Work Order ID 130110

Item ID: D5149-1 Accept ***N900040100*** Setup Start ***NS1***
Revision ID: Stop ***NS2***
Item Name: Fwd Step Base
Start Date: 2/23/2015 Start Qty: 4.00 ***4*** Cust Item ID:
Required Date: 2/23/2015 Req'd Qty: 4.00 ***4*** Customer:
Reference:

WORK ORDER NON-CONFORMANCE / UPDATE

Work Order: <u>130110</u>	DISPOSITION Rework ☐ Scrap ☐ Use-as-is ☒ Suspected Unapproved ☐	AGAINST DEPARTMENT/PROCESS			
Part No. <u>DS149-1</u>		Skid-tube ☐	Crosstube ☐	Water Jet ☐	Engineering ☐
NCR No. <u>15-4653</u>		Machining ☒	Small Fab ☐	Prod. Eng. Coord. ☐	Quality ☐
		Thermoforming ☐	Finishing ☐	Rec/Store/Packaging ☐	Other ☐
		Large Fab ☐	Composite ☐	Supplier ☐

D5149-1 FWD STEP BASE
(MAKE FROM D5149-1TRN)

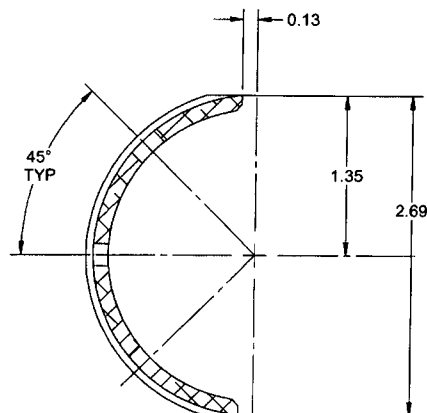
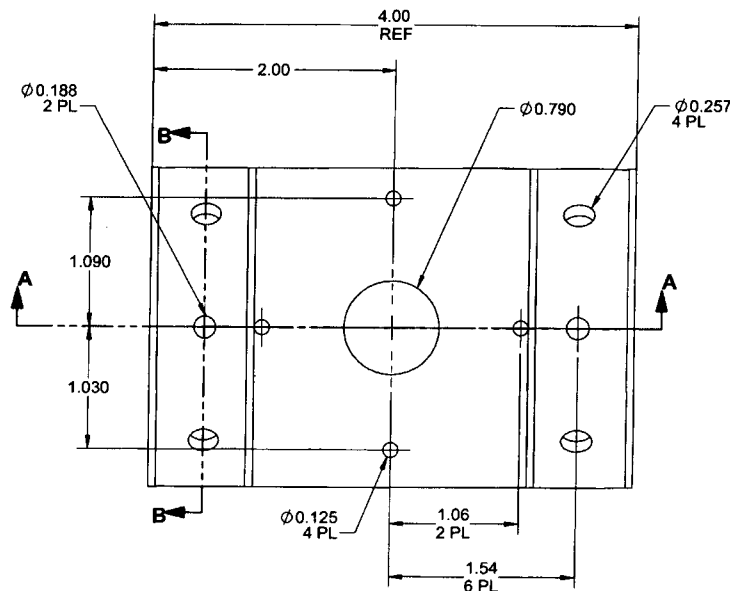
Top ridges have 0,030" Rad instead of 0,005" to 0,010" "Break sharp edges tolerance."

This operation was done on Doosan lathe

RC Program not verified

Program as been corrected for the 0,005 to 0,010" tolerance

USE AS-IS.
